Town of Milford Meeting Notice

Board or Commission: Conservation Commission

Date and Time of Meeting: Wednesday November 18, at 7.00 P. M

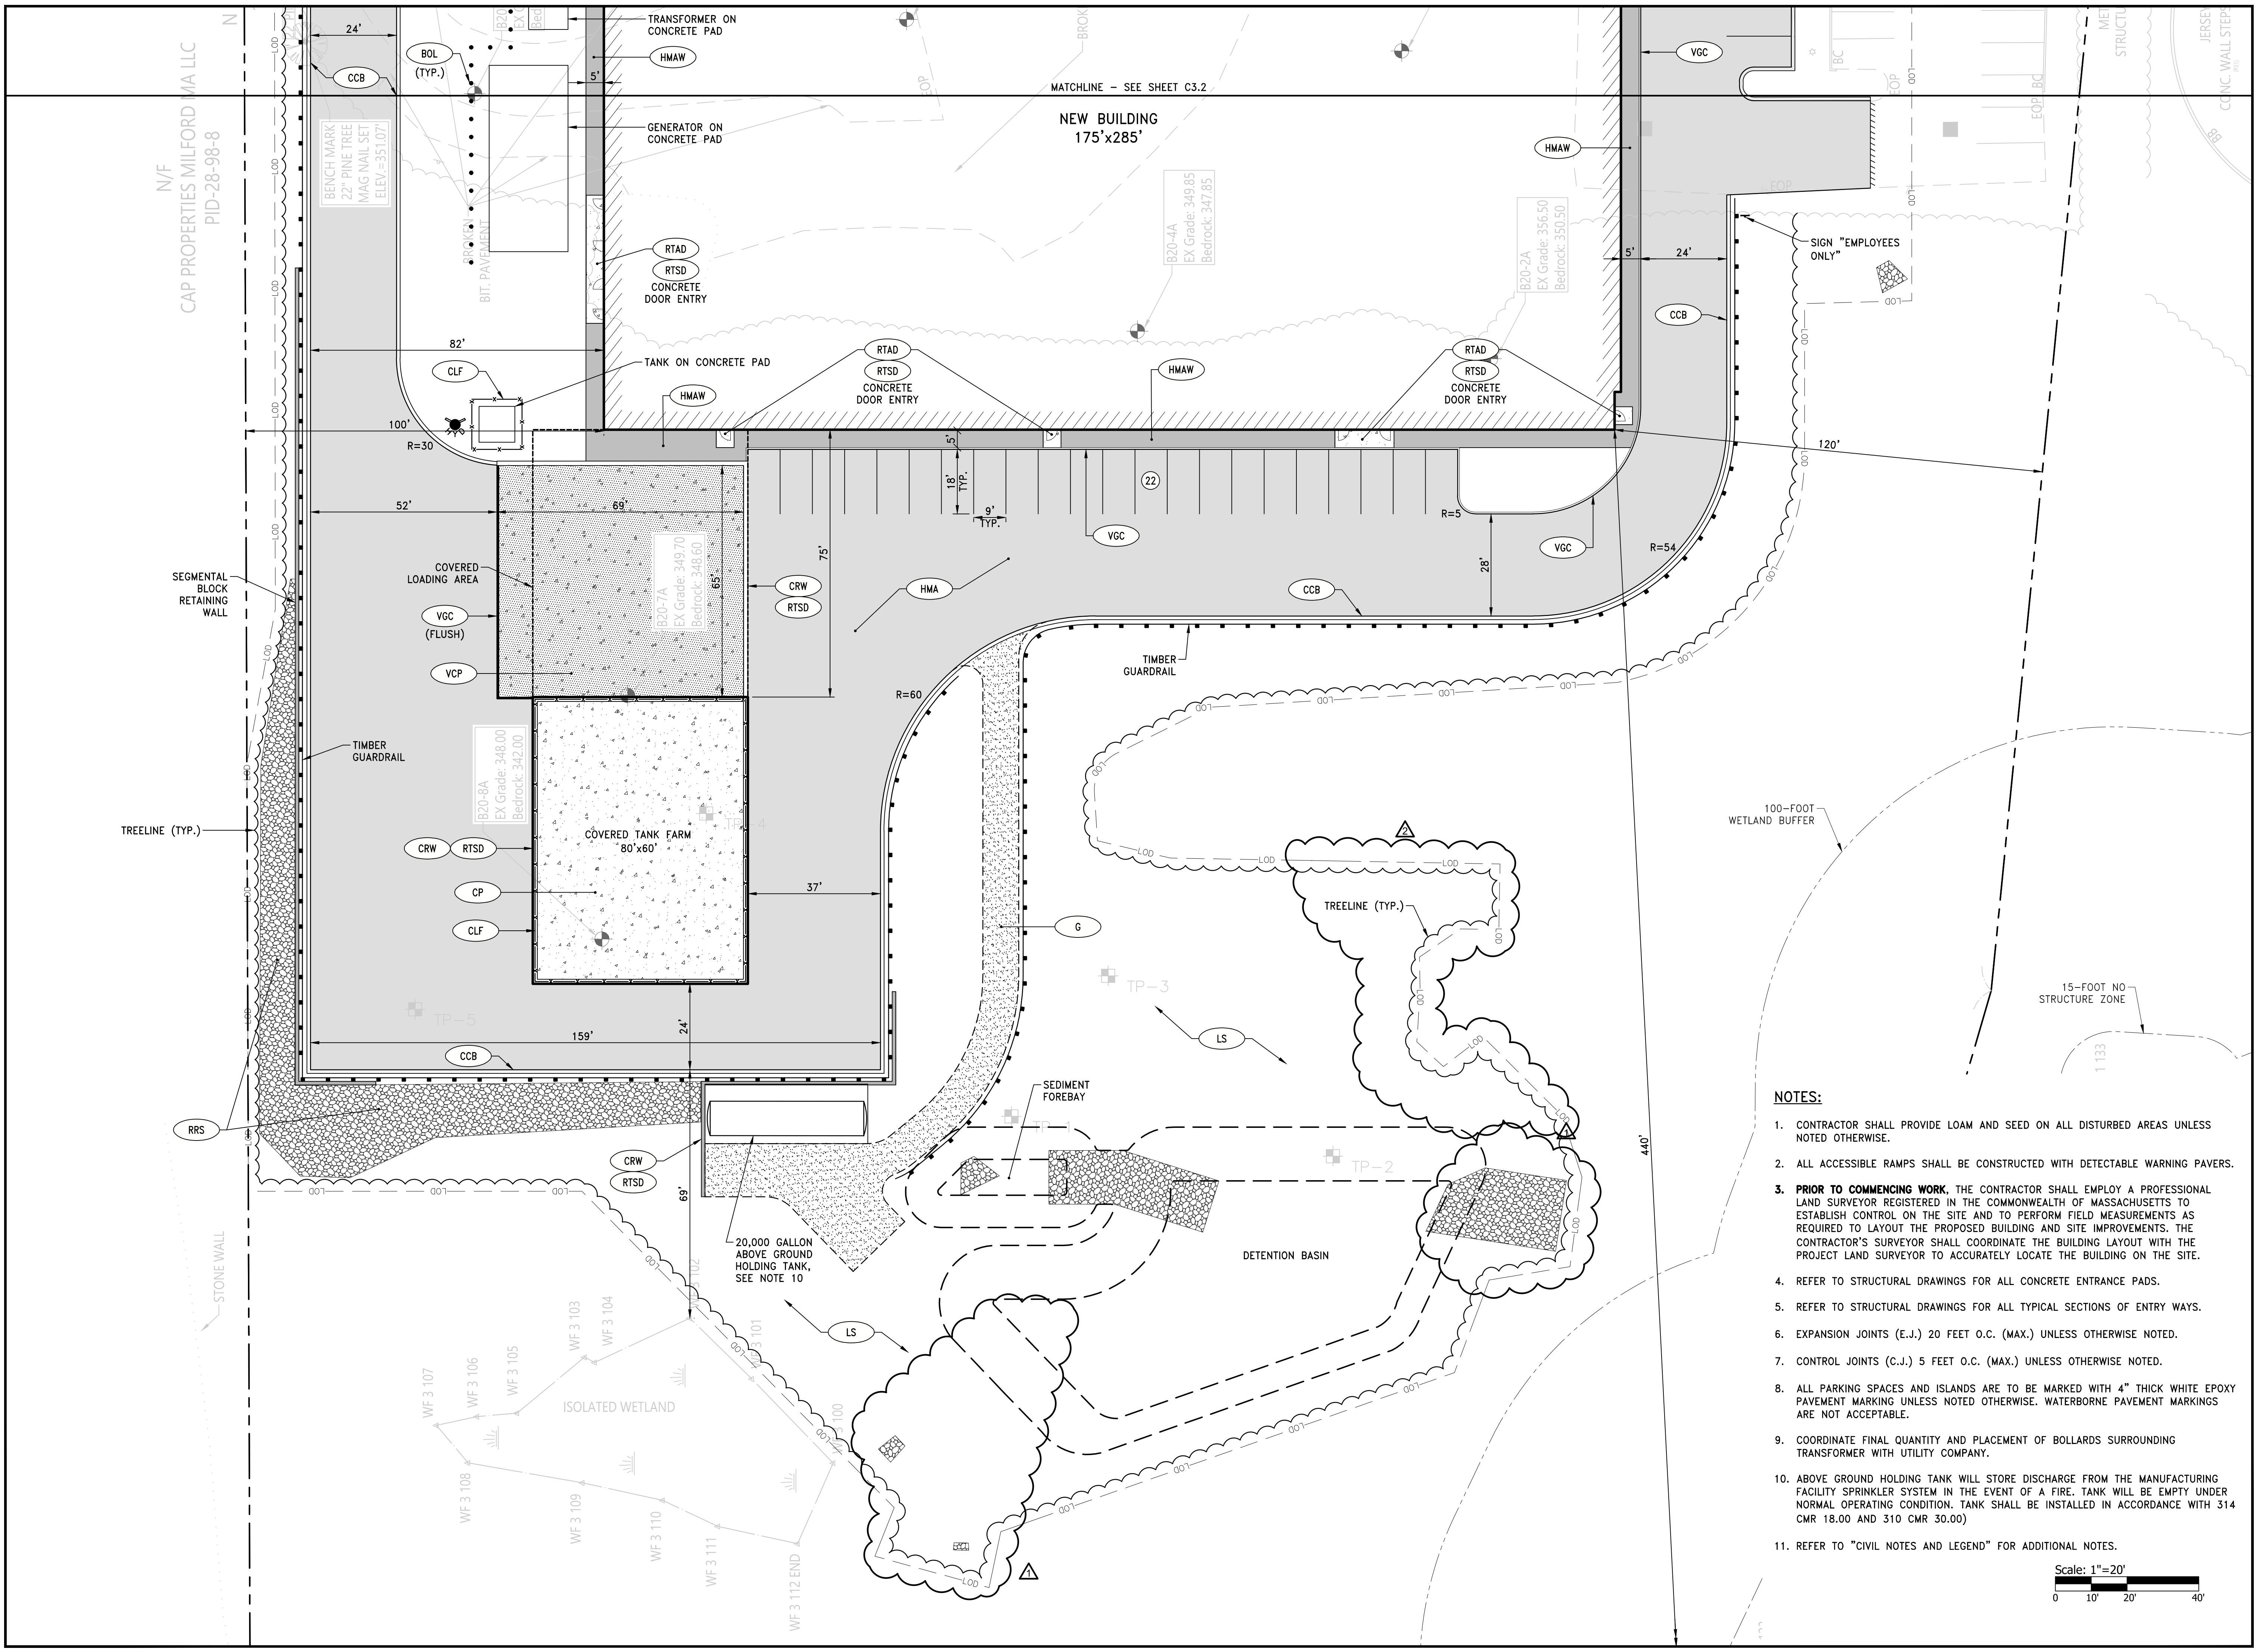
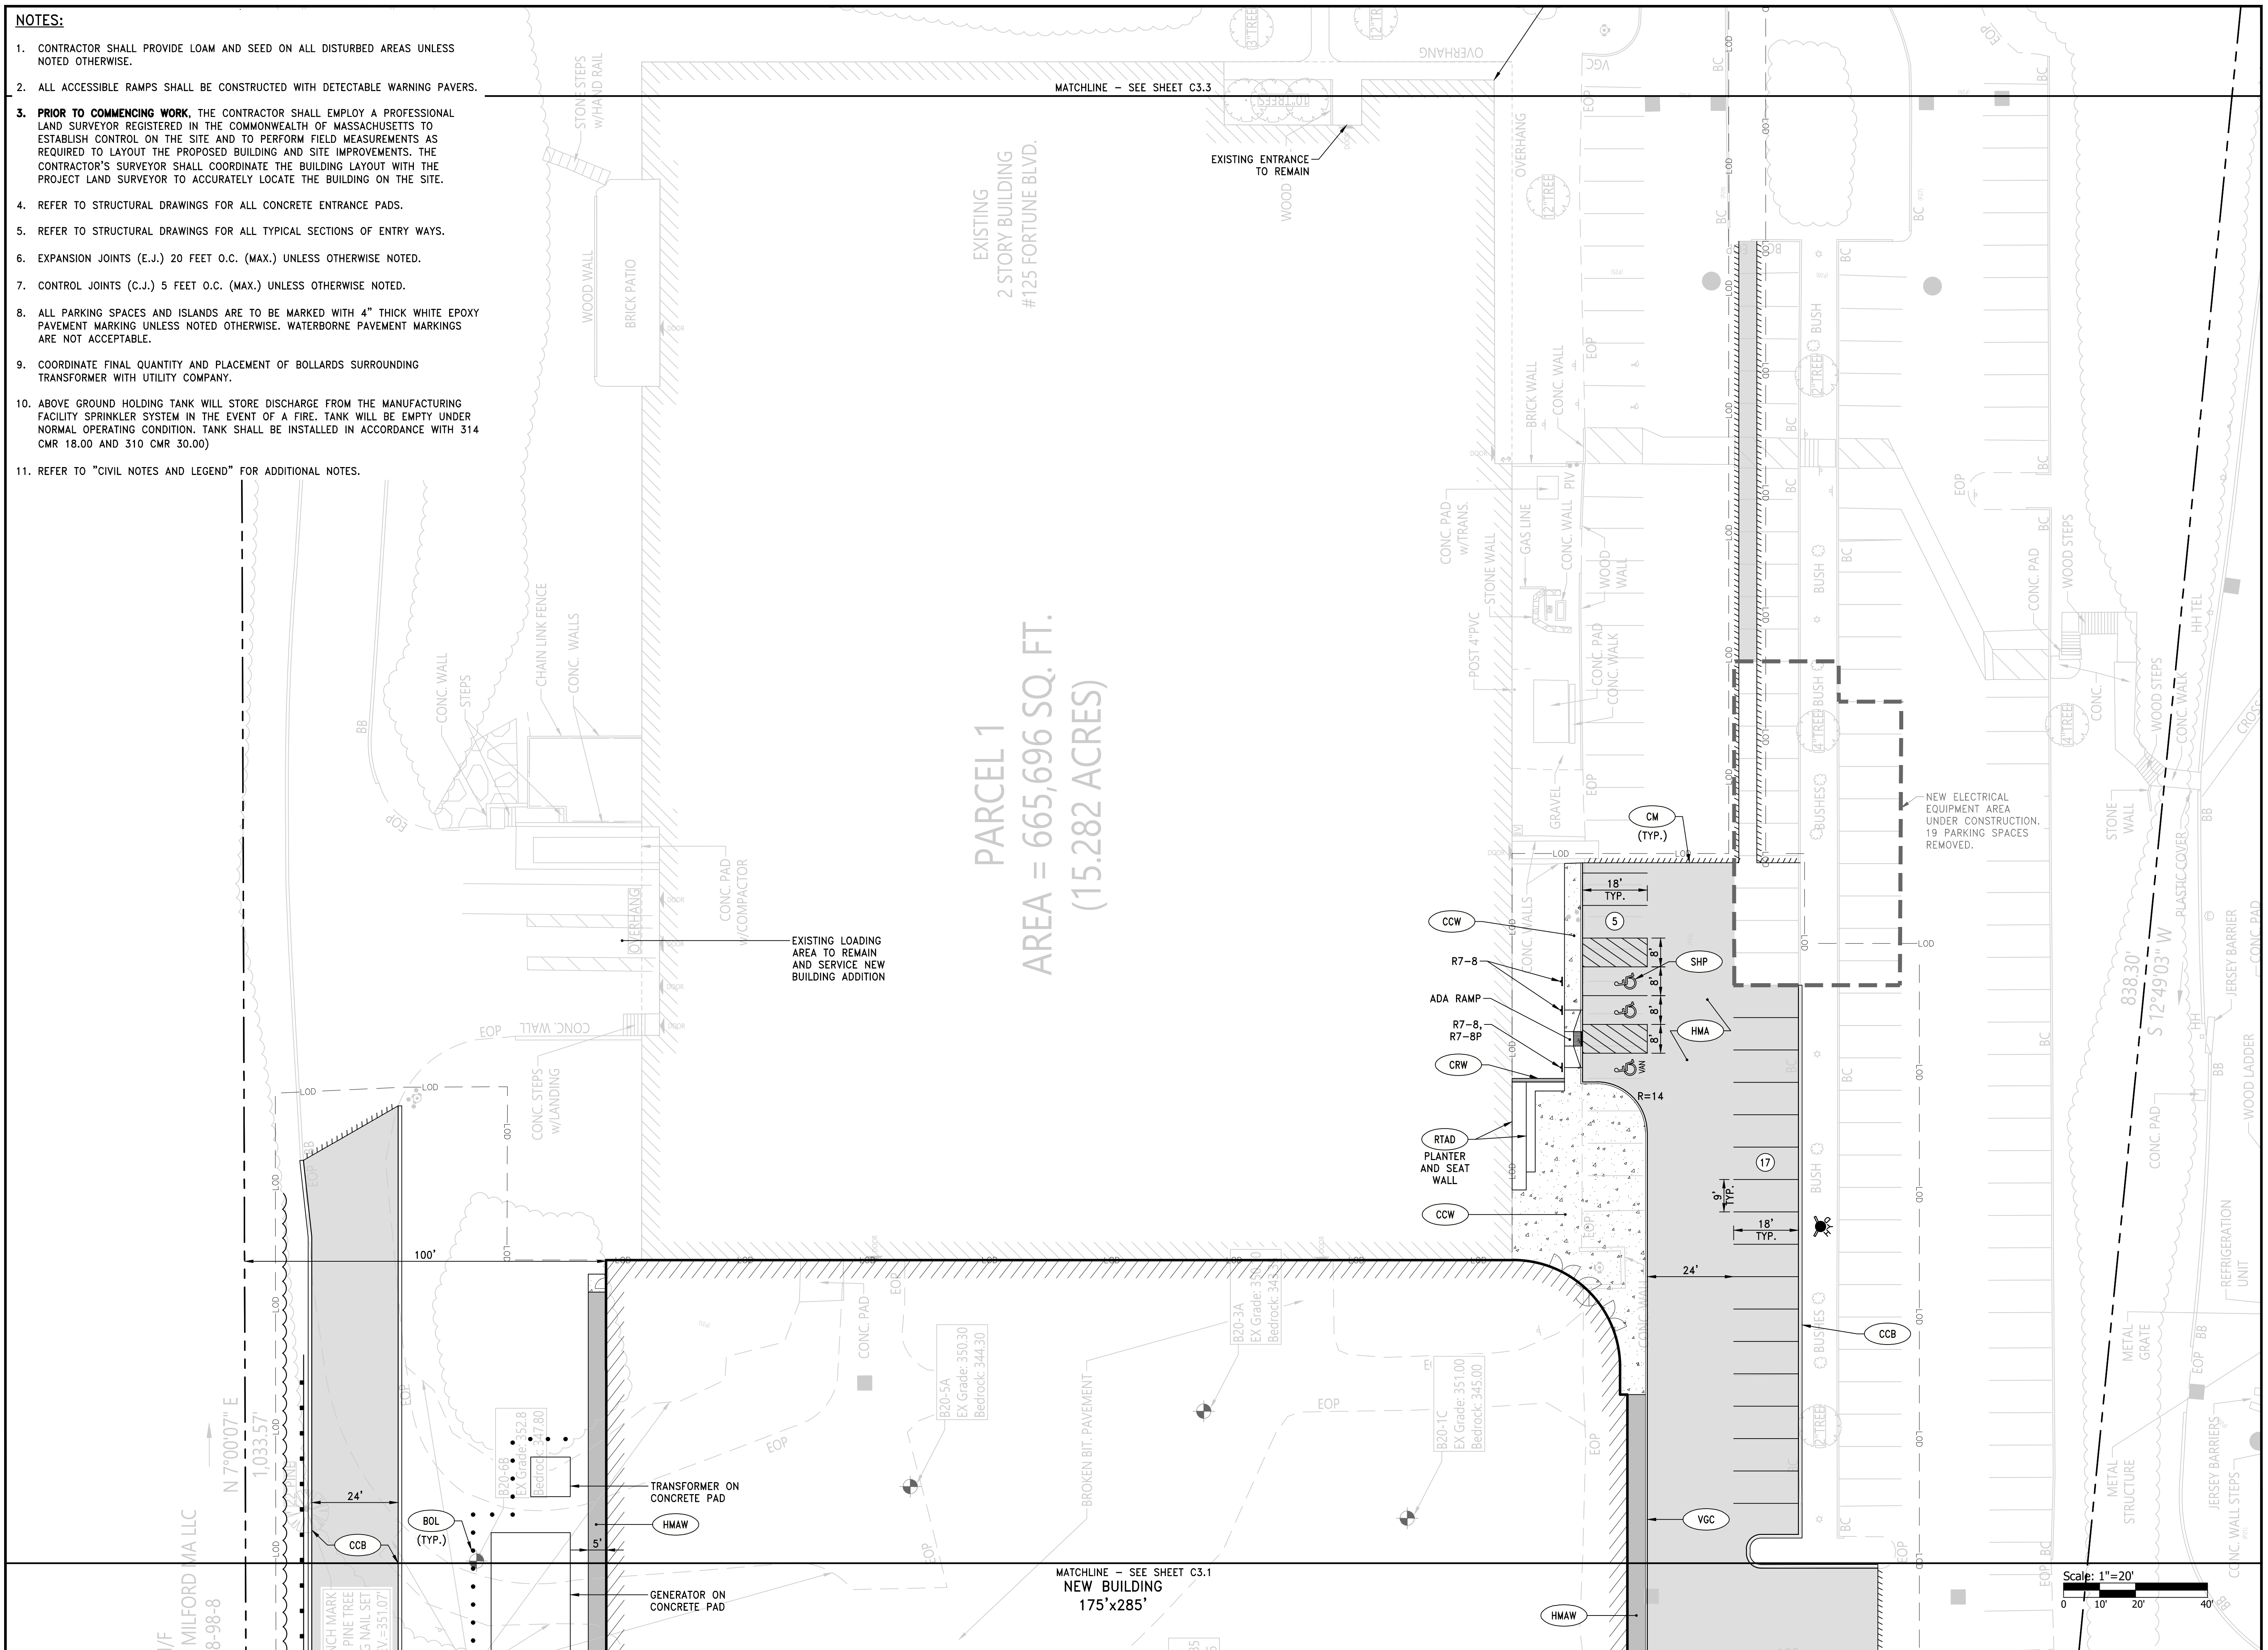
RESPONSE: *The erosion control detail on Sheet C-601 Civil Details 1 has been revised to include silt fence with the compost filter sock.*
